Staff Report & Recommendation

Historic Preservation Board

SUBJECT: HPB16-0071, **801, 807 & 815 Alton Road.**

The applicant, 2012 New Age LLC, Matteo Soldatini, is requesting a Certificate of Appropriateness for the retention of 5 existing parking spaces and an associated driveway within the front yard.

1984 Aerial Map

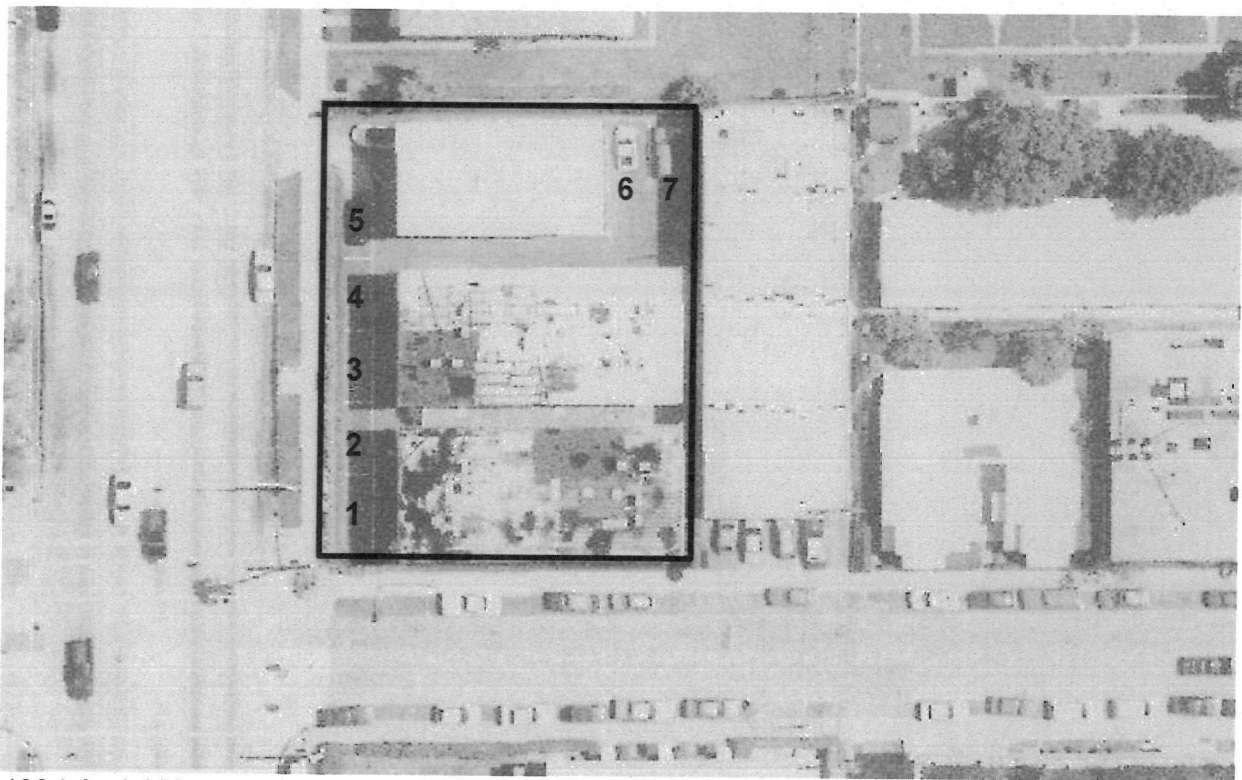
At a minimum, staff would recommend that the five parking spaces within the front yard be eliminated in order to provide additional landscaping. While it would be preferable to have the three pedestrian courtyard entries, as shown in the 1984 aerial photograph, reintroduced, staff recognizes that a hotel has operational needs. In this regard it is suggested that the parking spaces be converted to a driveway, reconfigured to provide a drop off area along Aton Road. This could be accomplished by eliminating the existing curb cut on 8th Street and introducing a curb cut in front of the center building, subject to the review and approval by Florida Department
